**Technical Service Bulletin (TSB)**  
**Vehicle displays Performance Limited Fuel System**

| <b>REFERENCE:</b>         | <b>TSB:</b> 08-106-24 REV. C<br><b>GROUP:</b> 08 - Electrical   | <b>Date:</b> | May 17, 2024 | <b>REVISION:</b>             | 08-106-24 REV. B                       |
| <b>VEHICLES AFFECTED:</b> | <b>2022 - 2023 (JL) Jeep Wrangler</b><br>This bulletin applies to vehicles built on or after January 01, 2022 (MDH 0101XX) and on or before February 19, 2023 (MDH 0219XX) equipped with a 2.0L I4 DOHC DI Turbo (Sales Codes EC1 and ECX). |              |              | <b>MARKET APPLICABILITY:</b> |  |

**Fig. 1**  
Location Of Harness Contact

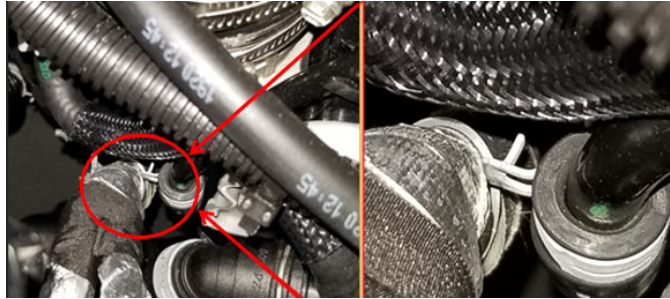
| <b>CAUSE:</b>             | Hose clamp contacting harness   |              |              |                              |  |

1. Inspect the harness for contact at hose clamp [Fig. 1](#).

2. Is there contact between the hose clamp and harness?
  - YES>>> Proceed to [Step 3](#).
  - NO>>> This bulletin does not apply. Use Inspect LOP **\*\*(08-19-AT-99)\*\*** to close this active RSU. Further diagnosis is needed.
3. Rotate the hose clamp to clear the harness.
4. Inspect the harness for damage.
5. Is the harness damaged?
  - YES>>> Proceed to [Step 6](#).
  - NO>>> This bulletin is complete. Use LOP **\*\*(08-19-AT-CC)\*\***.
6. Repair damaged harness. Refer to the detailed service procedures found in DealerCONNECT>Service library>Service Info under: 29 - Non-DTC Diagnostics / Circuit Testing Procedures / Standard Procedure/ Wire Splicing. Use LOP **\*\*(08-19-AT-DD)\*\***.
